**Brisbane Central Business District Bicycle User Group  
(CBD BUG)**

The CBD BUG is writing to you in view of our continuing concerns regarding the delivery of the pedestrianised Albert St occurring as part of the Cross River Rail (CRR) project.

The CBD BUG is writing to you regarding the proposed Albert St Plaza to be provided by the Cross River Rail Authority (CRRRA) to address three matters, the CRRRA consultation process, the design of the Albert St Plaza and CRRRA's failure to reference existing planning documentation. This letter has been prompted by the interactive 3D image CRRRA released on Facebook on 23 March 2023 (refer Figures 1 & 2)

Figure 3 - Cross River Rail Facebook Posting

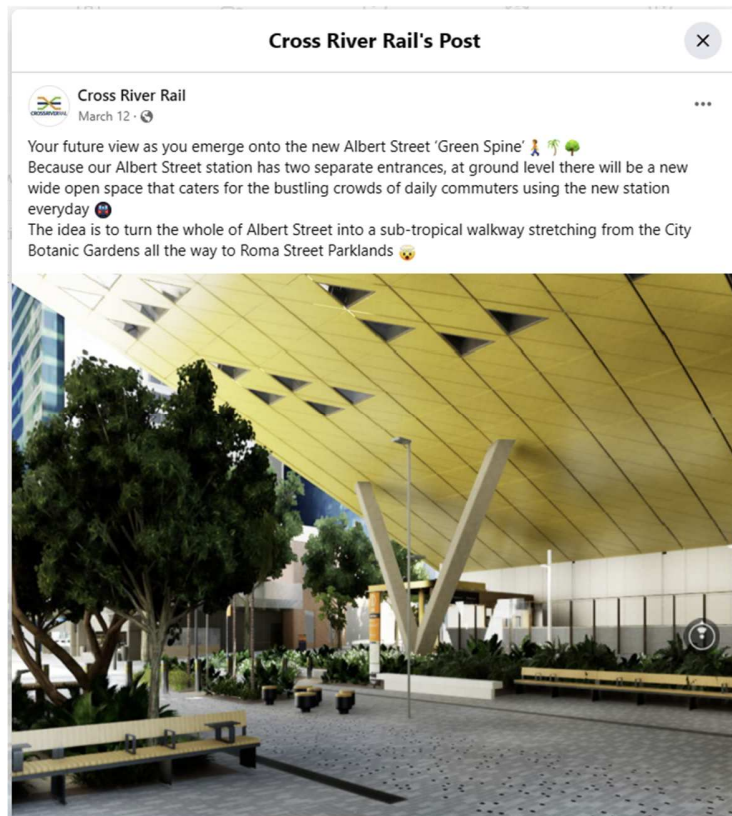
On the 8<sup>th</sup> & 12<sup>th</sup> of March CRR posted an interactive 3D image on Facebook (Figure 3 & 4). From what can be seen in the postings nothing has been amended since the workshop was held. All the issues identified in our letter in 2023 are still present.

A key question, on which we are still to receive a response, is whether modelling has been performed to determine if the very cluttered CRR design for Albert St can cope with the anticipated pedestrian and cyclist movements.
